PRELIMINARY/ FINAL DRAINAGE REPORT FOR RIVERBEND CROSSING FILINGS NO. 1 AND 2

SEPTEMBER 2018

PCD FILE NOS:
SP 187
SF 1843
SF 1844

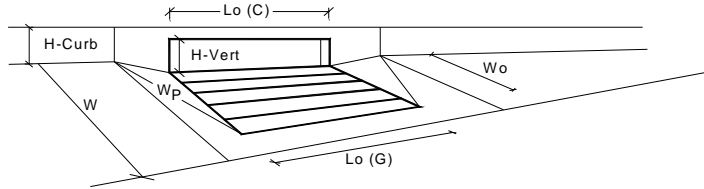
Revise longitudinal slope. Inlet is at grade.

Revise inlet calc. Construction plans show this as an at-grade inlet.

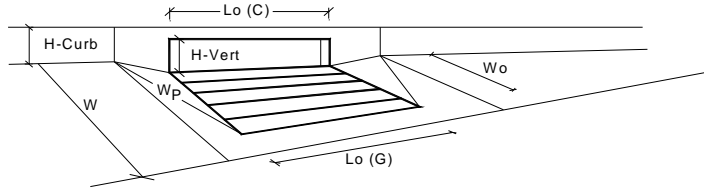
Revise. P&P shows
1% slope towards the
inlet.

Revise inlet calc. Construction plans
show this as an at-grade inlet.

Revise inlet calc. Construction plans show this as an at-grade inlet.

Detention Basin Outlet Structure Design

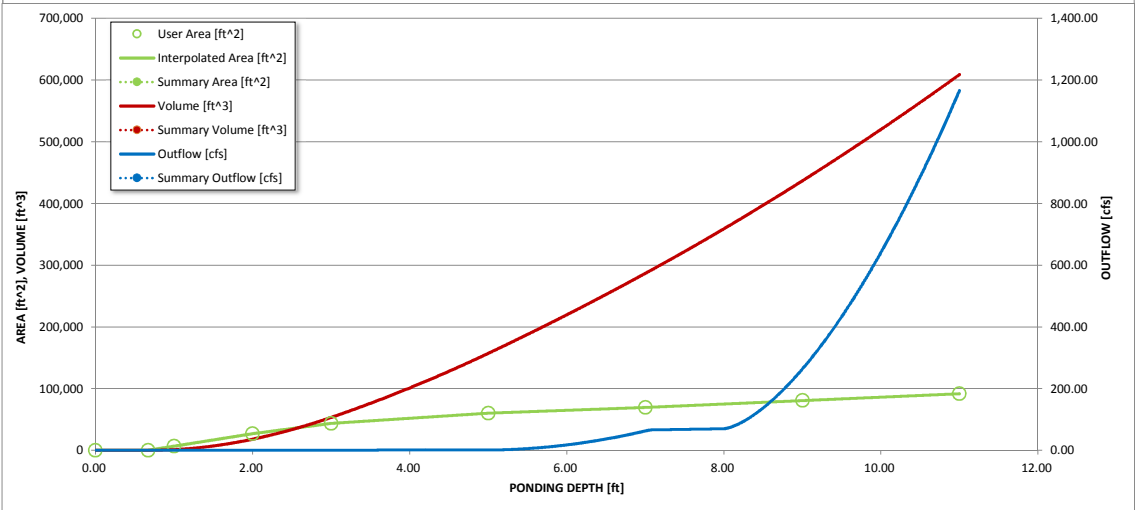
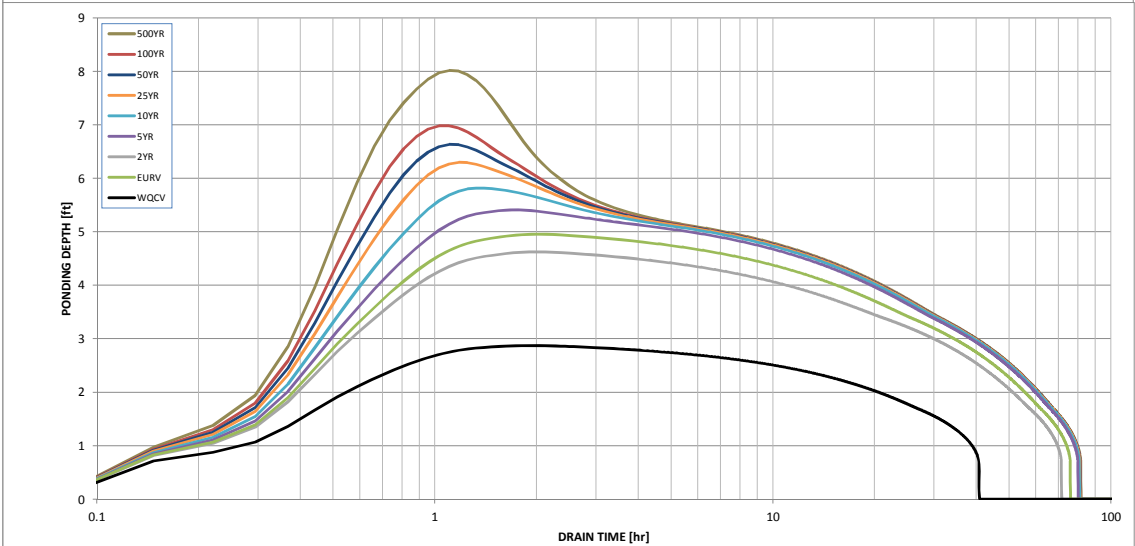
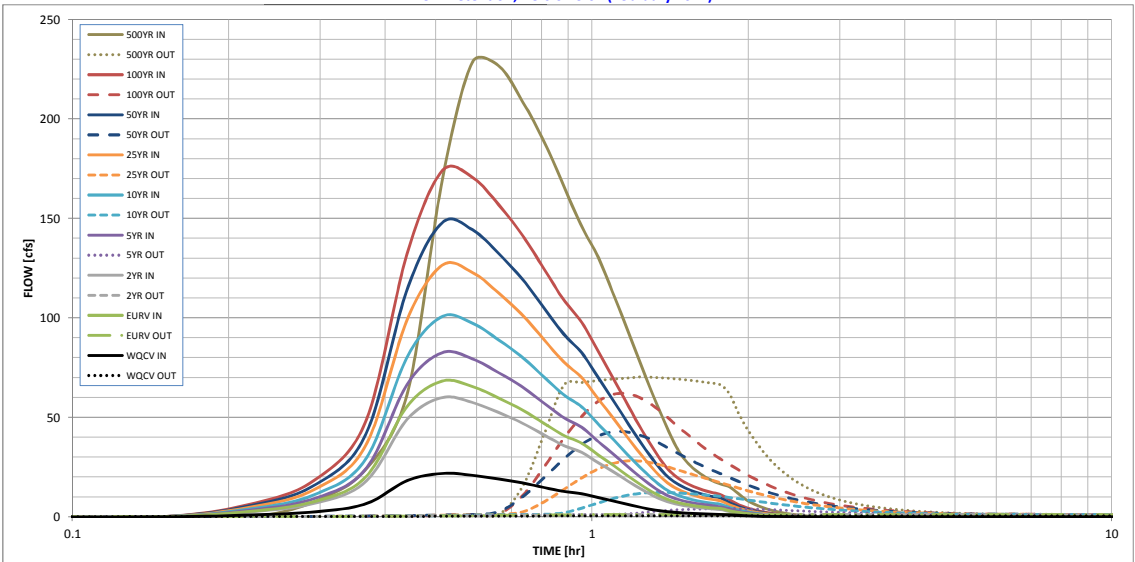
Outlet design does not match the construction drawings. Revise.

FLOODWAY DATA

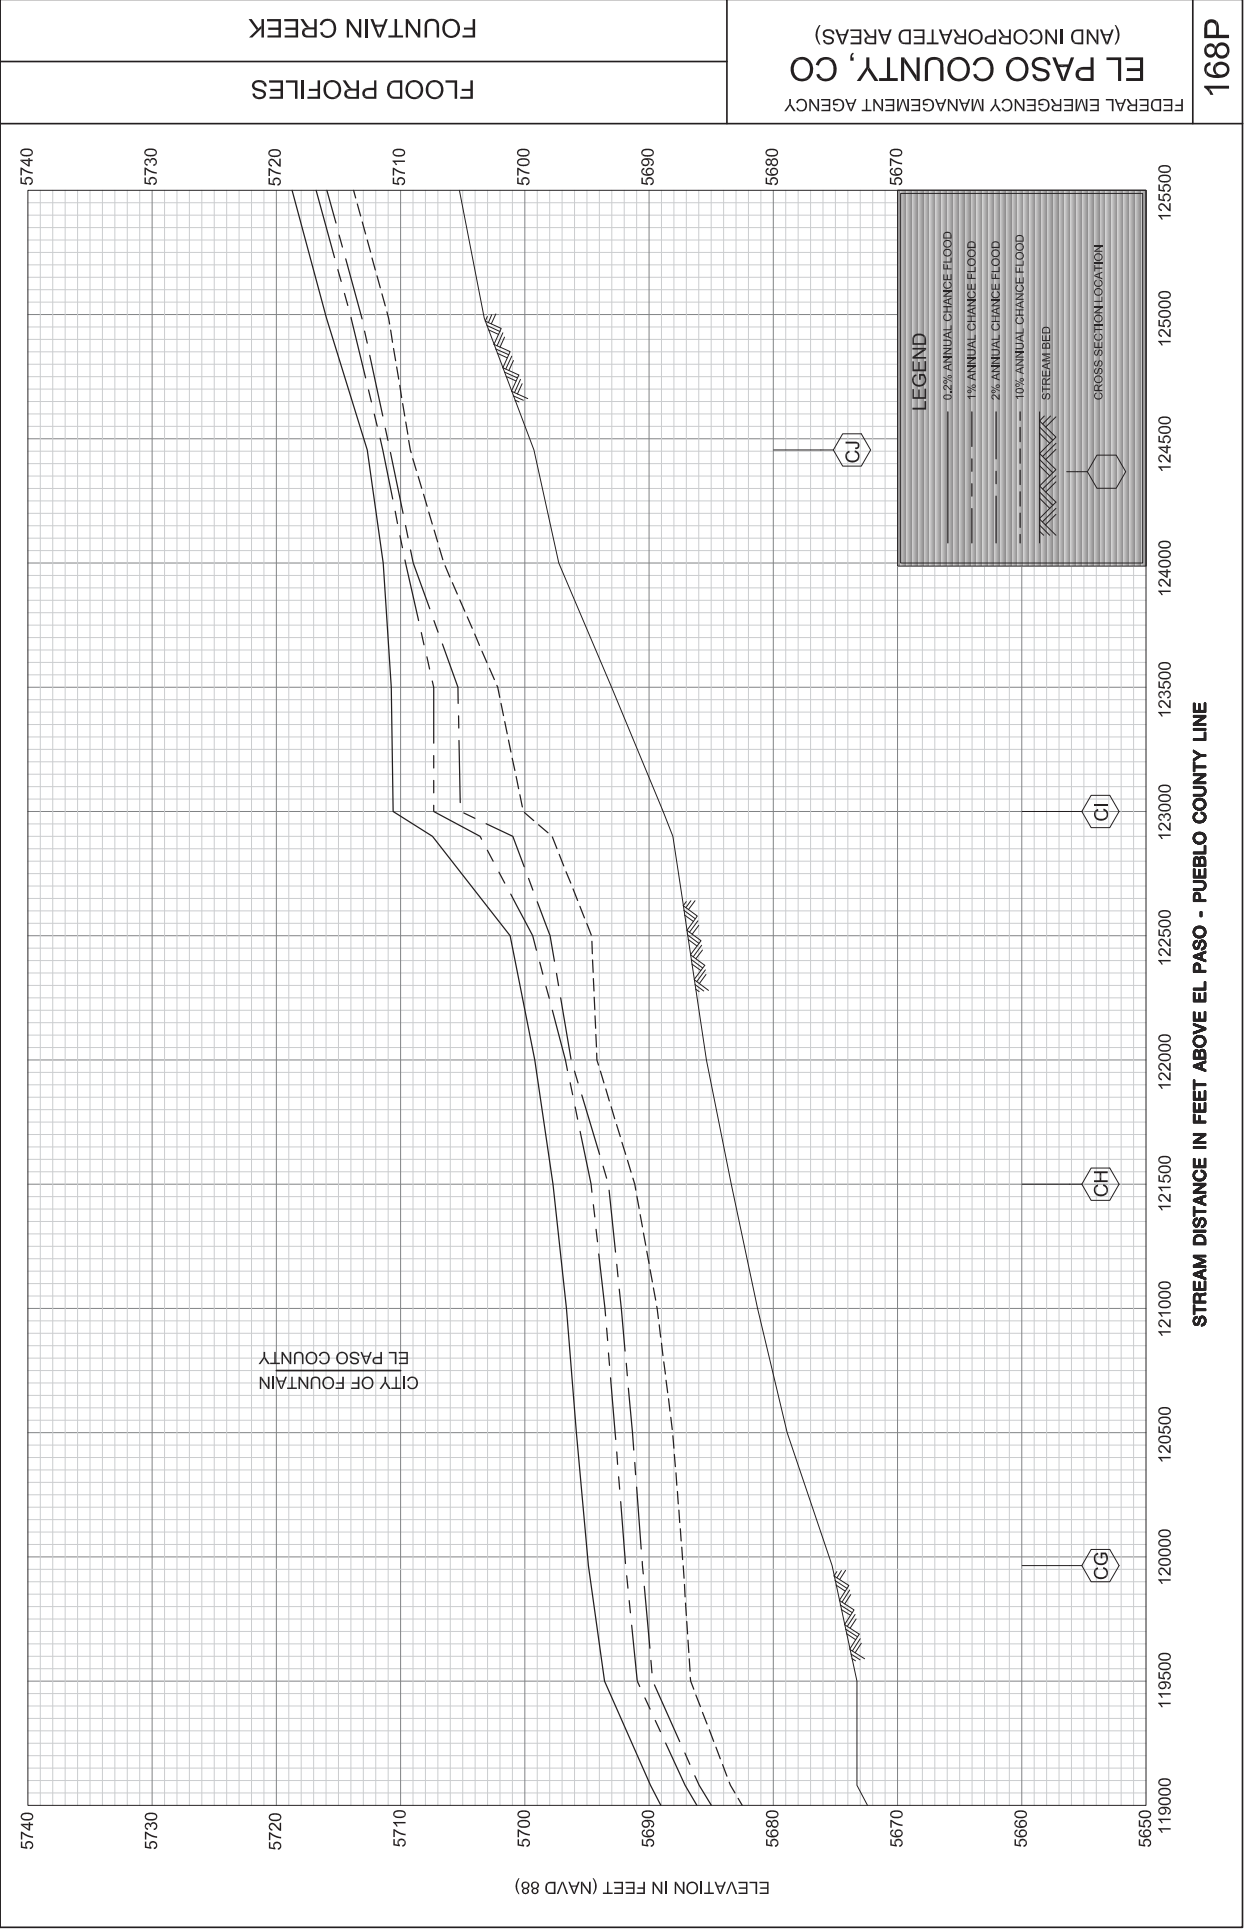
Update Project Name
and ID. Staff's
assuming this is for
the channel in basin
A.
